City of Madison  
Landmarks Commission  
Dept. of Planning and Development  
215 Martin Luther king, Jr. Blvd  
P.O. Box 2985  
Madison , WI 53701-2985

re: Certificate of Appropriateness for 2122 Van Hise Ave

Associated Housewrights, on behalf of Jean Haughwout and Jon Keevil, owners and residents of 2122 Van Hise Ave., request permission to replace 5 window units at said property.

Southeast facing

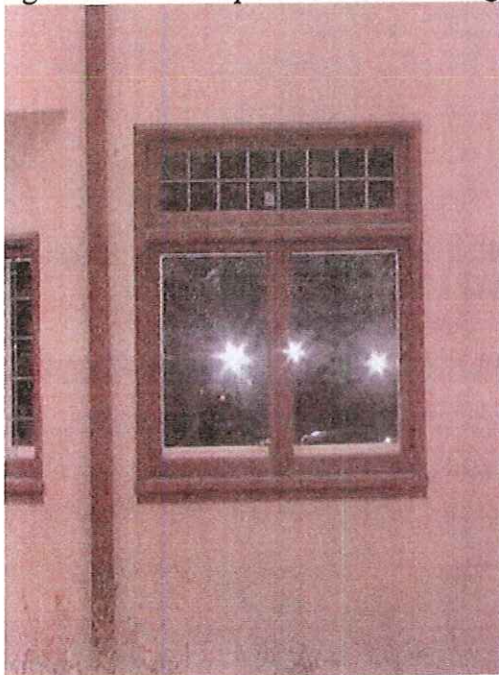
- For the existing non-lead-ed windows: The Commission approved the issuance of a Certificate of Appropriateness for the replacement of the wood windows, as proposed, with new windows that have exterior applied muntins
- For the existing lead-ed windows: The Commission required that the owners repair or restore the existing lead-ed glass windows, and did not approve the proposed replacement windows. The Commission noted that if the repair and restoration is not possible due to the condition of the windows, then the owner should return to the Landmarks Commission for further review and consideration.

We propose to replace these windows with Marvin brand wood insert windows (leaving the original exterior sill and casing in place) which will include interior applied lead mullions to match the divided light pattern of these original windows.

East facing

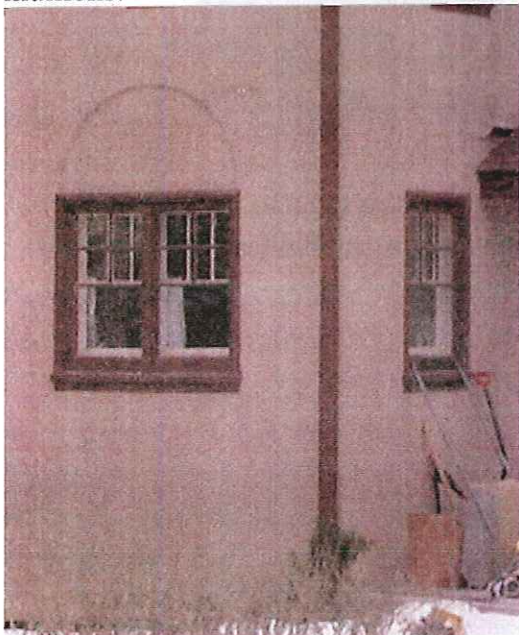
The third dining room window has a divided light transom with lead mullions but no divided lights at the two operable sashes. Original blueprints confirm this lack of mullions.

We propose to replace this window with a Marvin brand wood insert window.
